PLAN CHANGE 92 – SUMMARY OF CHANGES TO RECOMMENDATIONS BASED ON COUNCIL EVIDENCE – 6 SEPTEMBER 2023

The purpose of this document is to update the recommended changes which were published in the following documents at the time of releasing the Section 42A report:

Attachment A – Recommended Changes to District Plan Maps

Attachment B – Recommended Changes to District Plan Text

ENDS

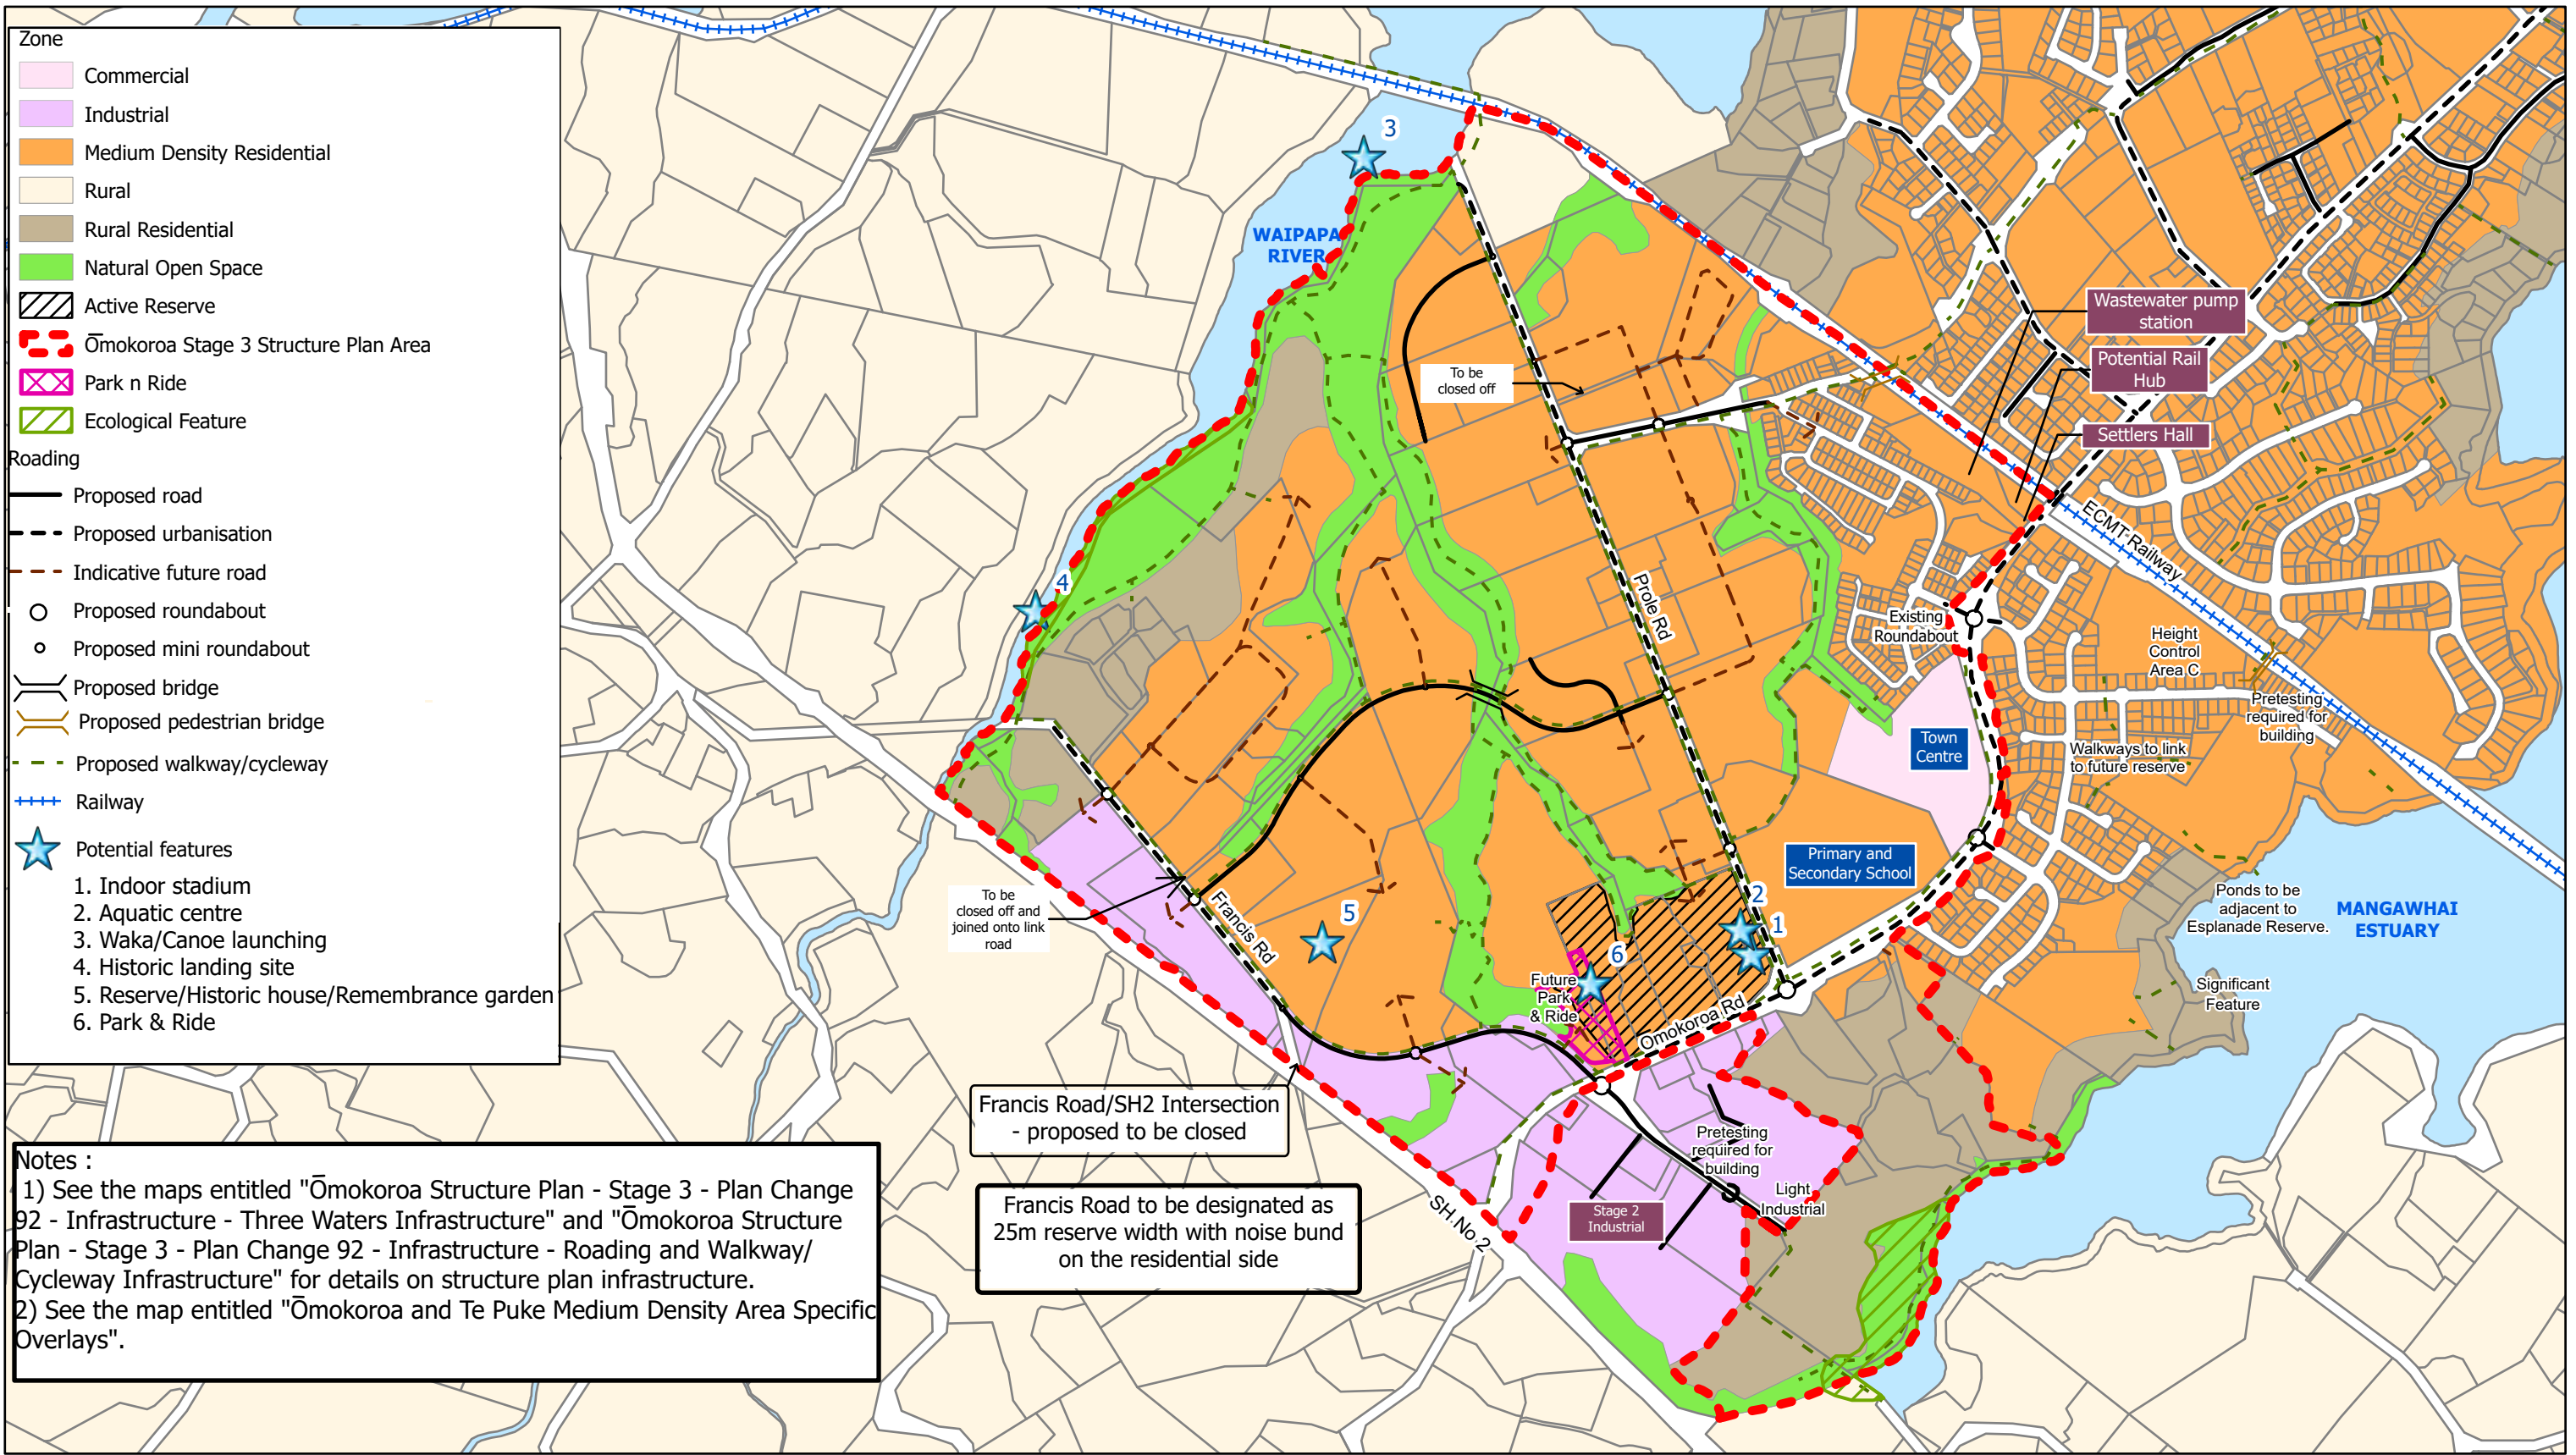
- **Ōmokoroa Plan Change 92 – Proposed Zoning Map:** Further amend the boundary of significant ecological feature U13/145, as it applies to 467E Ōmokoroa Road (M & S Smith) by removing the area shown as (b) in Plate 2 of the assessment from Nautilus Contracting Limited.

Note: Approx 25% of Area (a) above, as submitted by Mr & Mrs Smith, is within existing esplanade reserve, and when future subdivision happens a MHWS fix will place all of this within a 20m wide esplanade reserve adjustment.

Note: Area (b), as submitted by Mr & Mrs Smith, is to be landward of the revised DP SEF.

- In Plate 1 the DP SEF alignment remains unchanged. This recognises that: (i) some of Area (a), as submitted by Mr & Mrs Smith, is actually esplanade reserve; (ii) the balance would become esplanade reserve upon any future subdivision; (iii) some of the terrain has been modified; (iv) the steep batter alongside is unstable and should not be grazed or otherwise developed.

- In Plate 2 the DP SEF alignment can be adjusted to align with the extent of the wetland feature – which would develop in the absence of grazing – and which would reasonably closely align with the proposed Plan Change 92 Natural Open Space Zone (NOSZ). This supports Mr & Mrs Smith’s submission respecting Area (b).

- In Plate 3 the DP SEF alignment remains unchanged. This recognises that approx. half of the site is within the freshwater wetland feature – which would develop in the absence of grazing – and includes most of the very steep batter which is erosion prone. Upon future land subdivision all of this area would become esplanade reserve after MHWS refix. This alignment also accords with the NOSZ alignment referred to above. On balance, any ground within Area (c) which is not captured by wetland values or very steep erosion-prone terrain is somewhat insignificant. On that basis it seems meaningless to alter the DP SEF at this site.

- The proposed amendment of the District Plan SEF landward line is almost identical to the Plan Change 92 Natural Open Space Zone line. In is sensible for these to be generally consistent.

ŌMOKOROA STRUCTURE PLAN - STAGE 3 - PLAN CHANGE 92

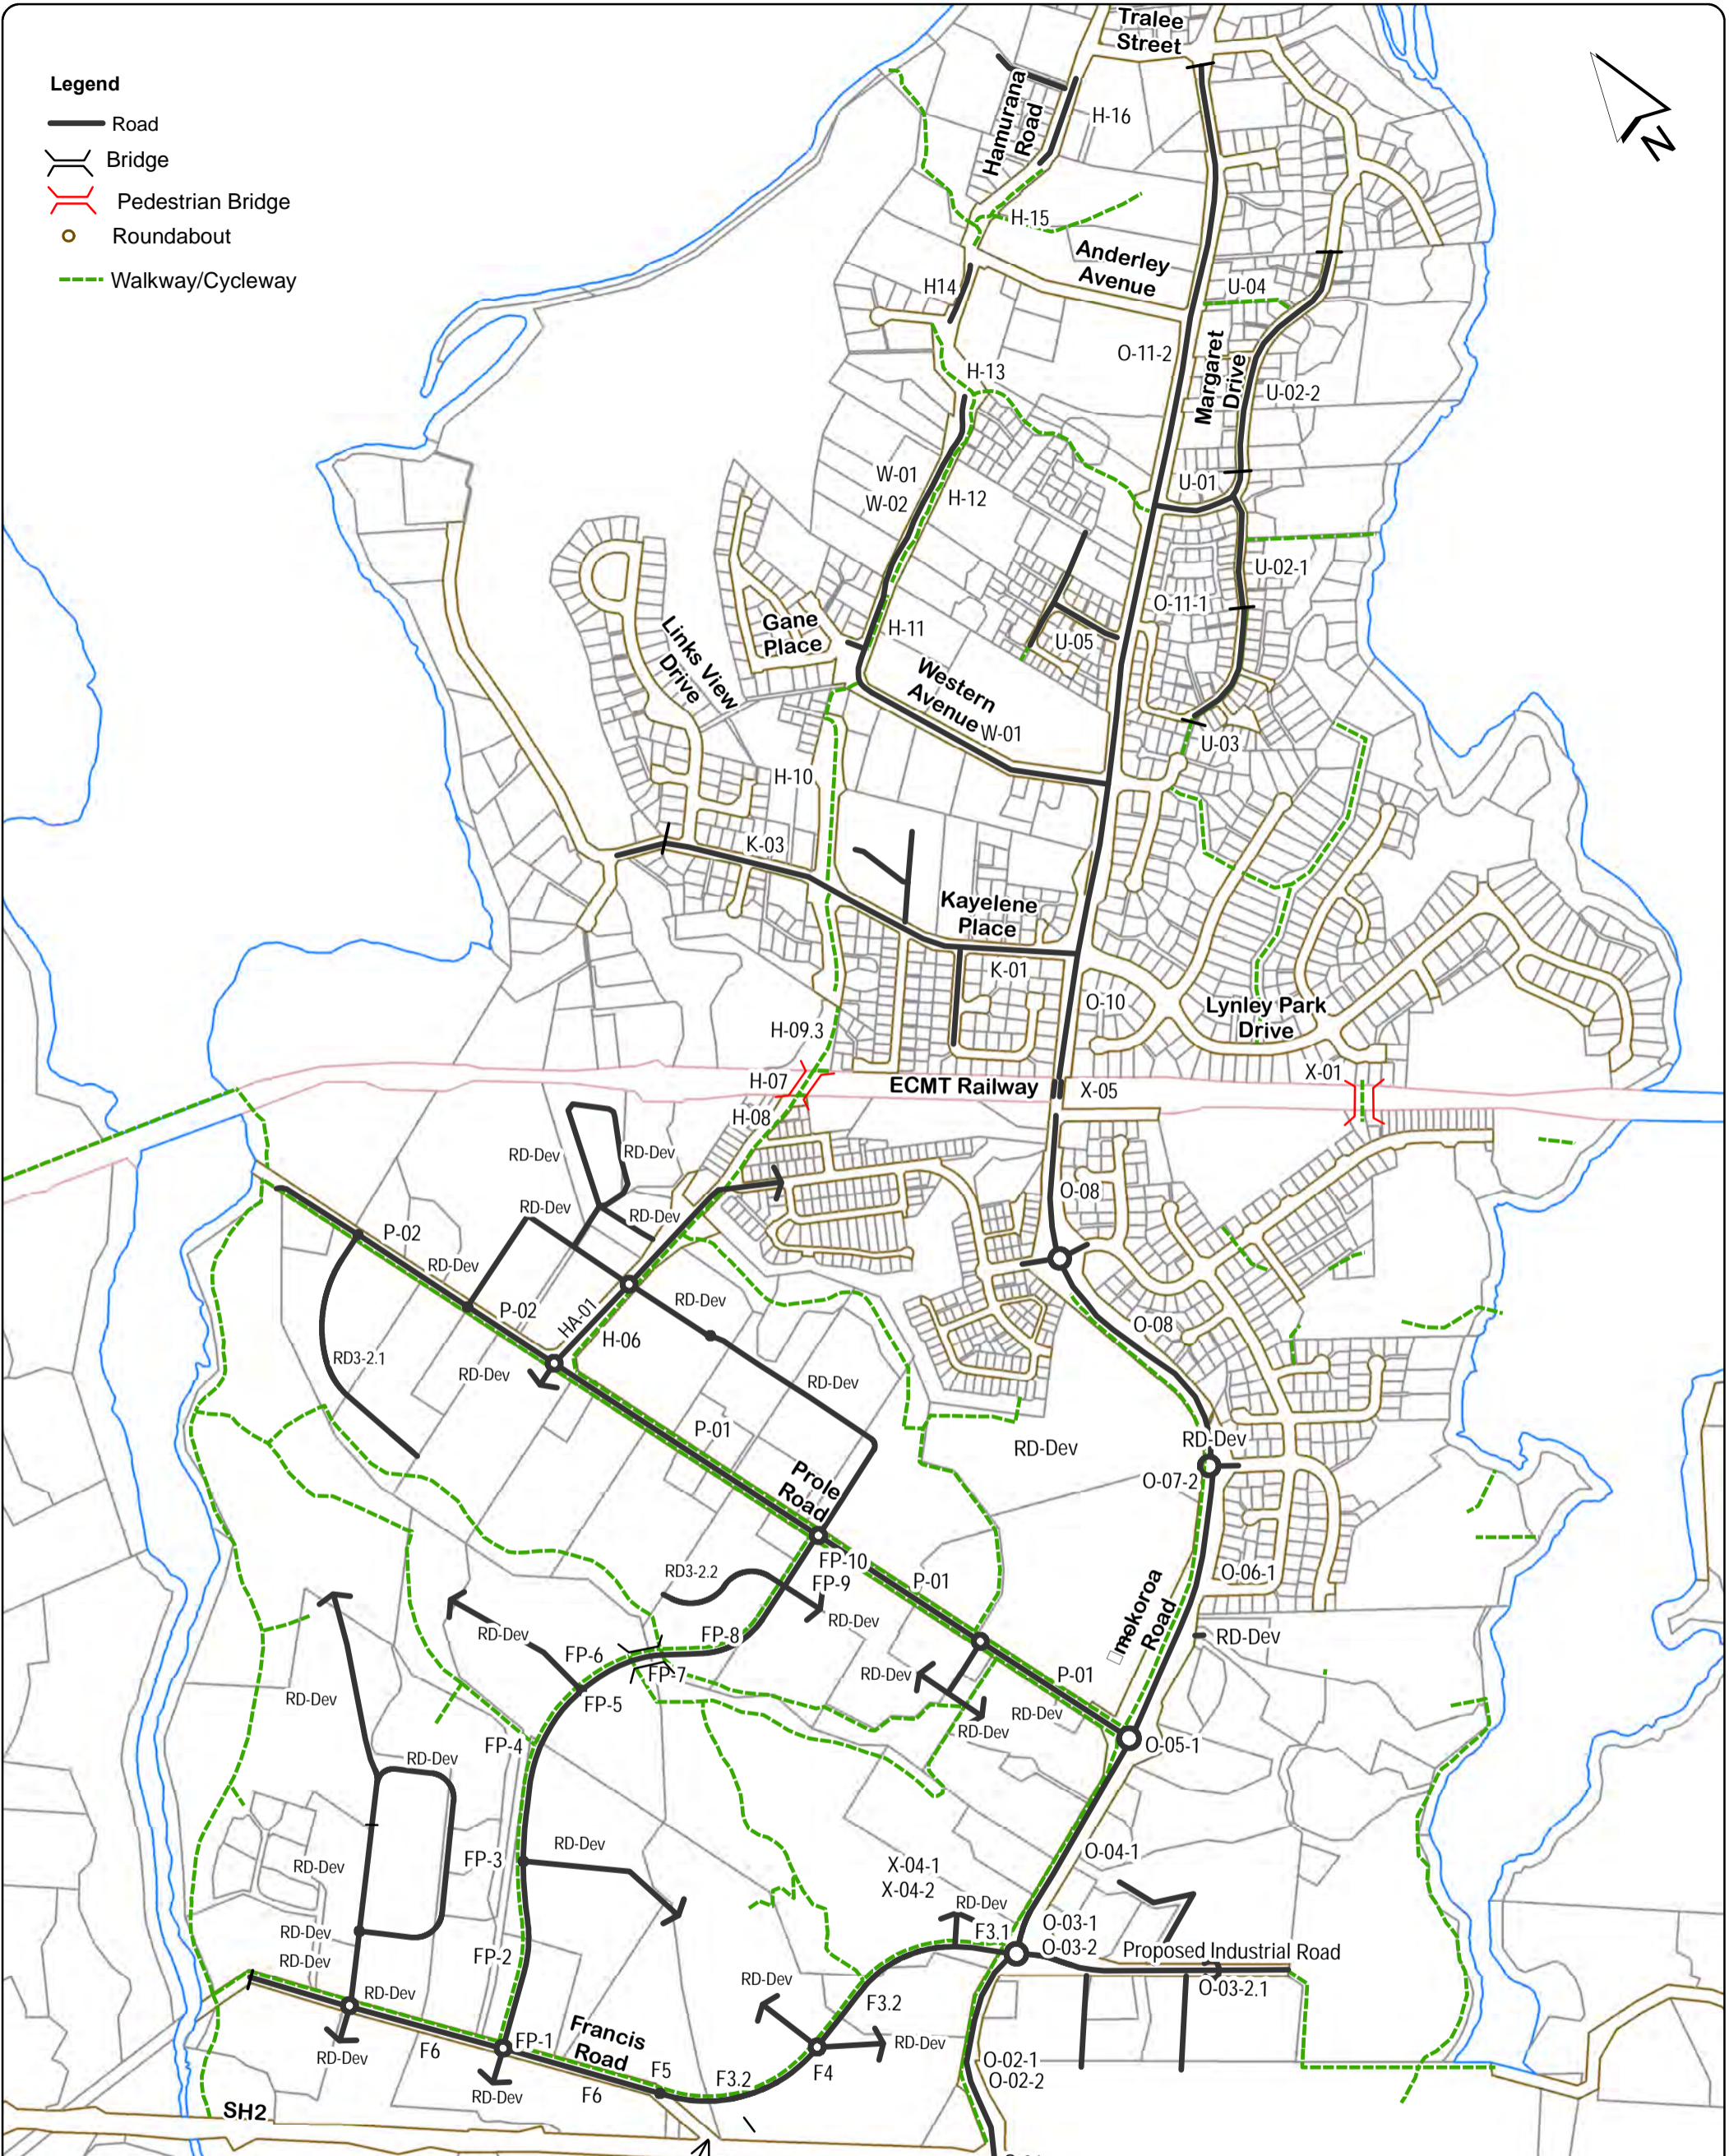
- **Ōmokoroa Structure Plan – Stage 3 – Concept Plan:** Further amend the concept plan to match changes to the zoning map and structure plans.
- **Te Puke Structure Plan – Plan Change 92 Infrastructure – Three Waters Infrastructure:** Delete projects WWINT-1 and WWINT-2 from the structure plan.
